Re: MPC #1-SE-15-C and #1-I-15-UR
1130 Mourfield Road

RE: 12-14-RZ Mourfield Road, Beals Creek

My name is Sam Mayes. My residence is located at 1405 Mourfield Rd, Knoxville, TN. I am writing in regard to the conceptual plan that was submitted for the subdivision that is currently proposed along Mourfield Rd. My concerns include the density of the proposed layout, safety concerns with access from the homeowners onto Mourfield Rd, adherence to local, state, and federal stormwater regulations, erosion concerns due to the steep topography for the existing and proposed layouts, and the aging infrastructure along Mourfield Rd.

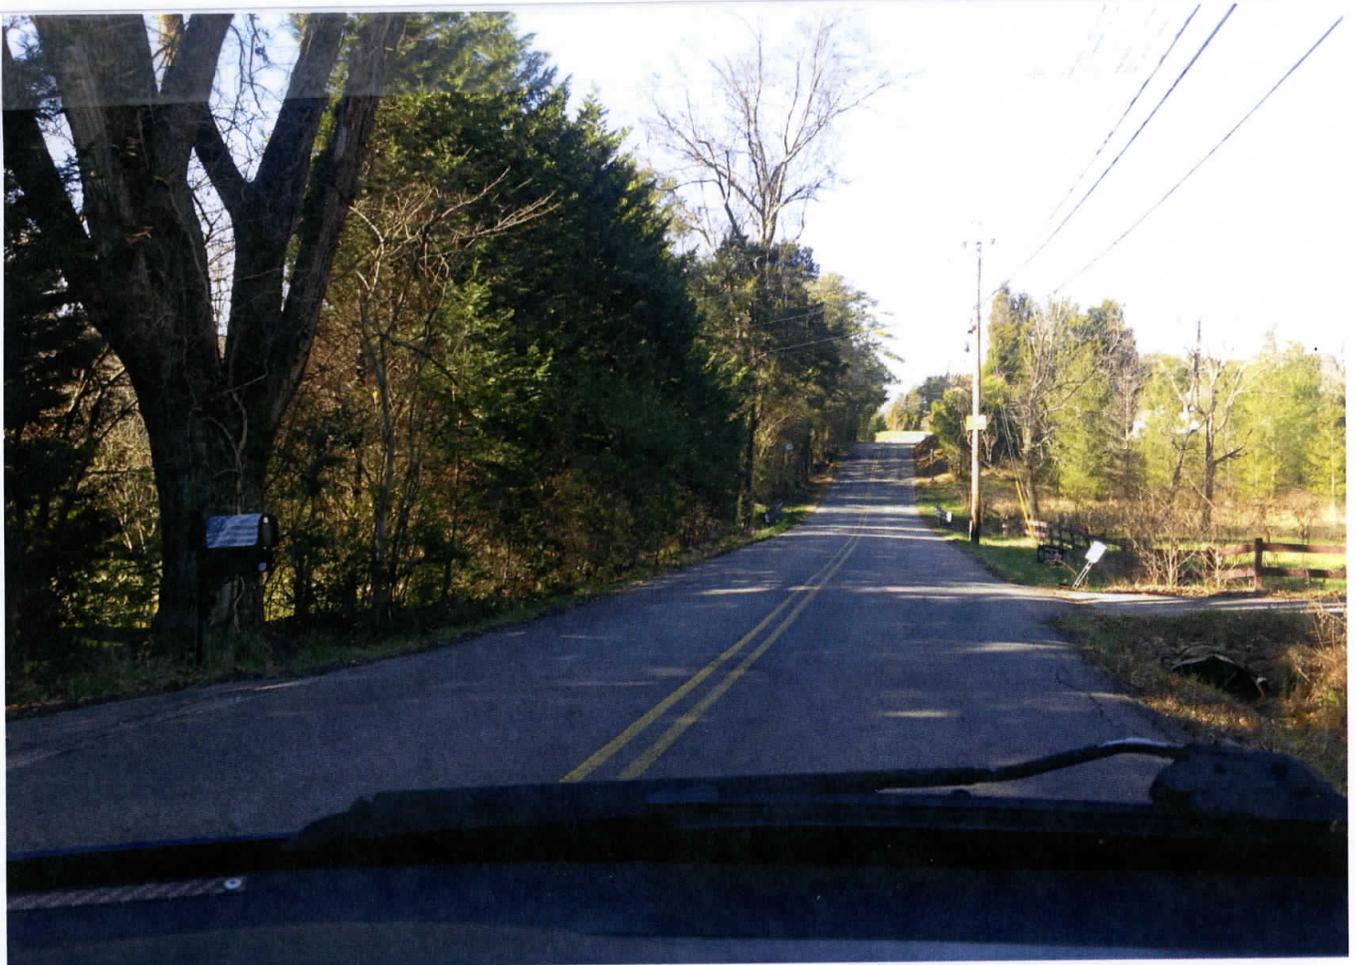
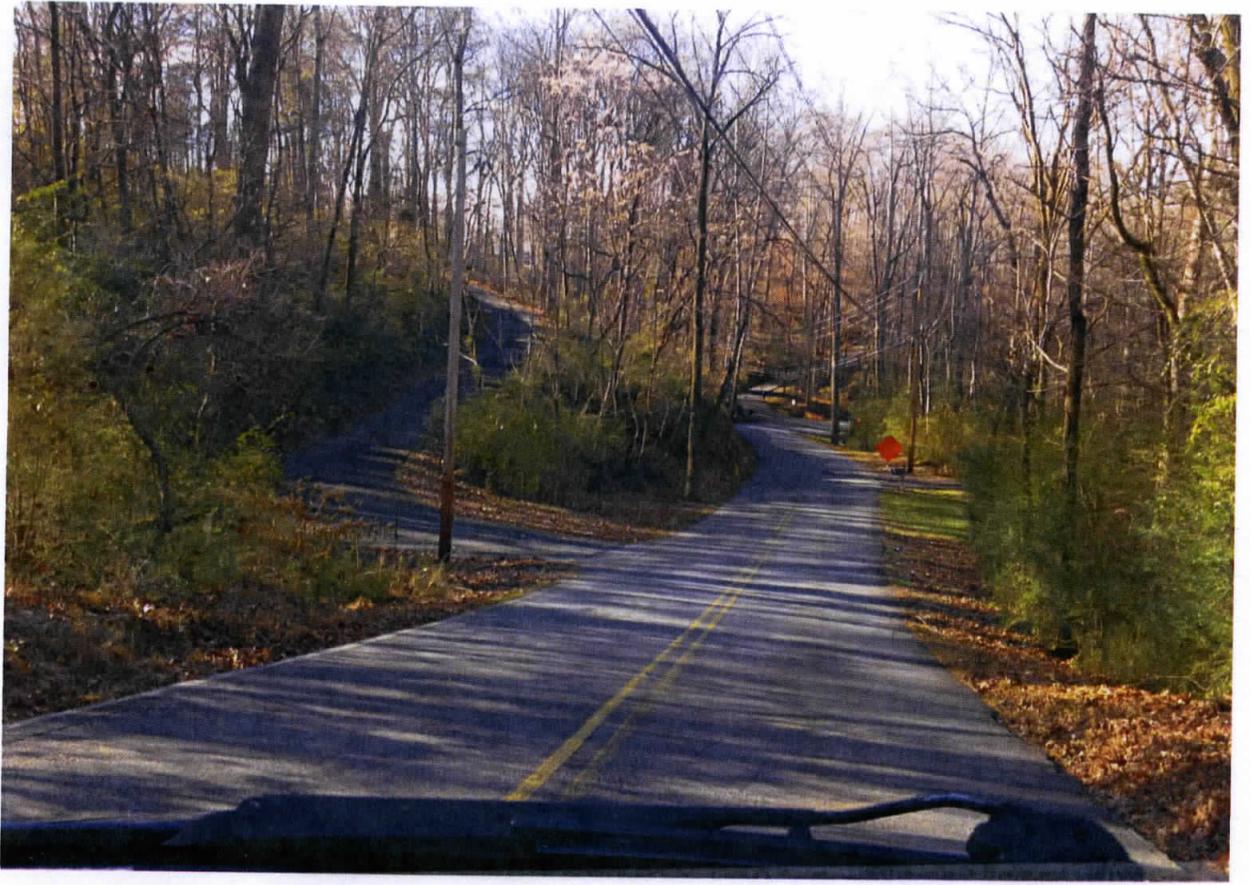
See attached pictures of the mature trees in the center of the property, looking north and south from the current driveway of the property on Mourfield Road, and driving south to north on Mourfield Road toward Westland Drive.
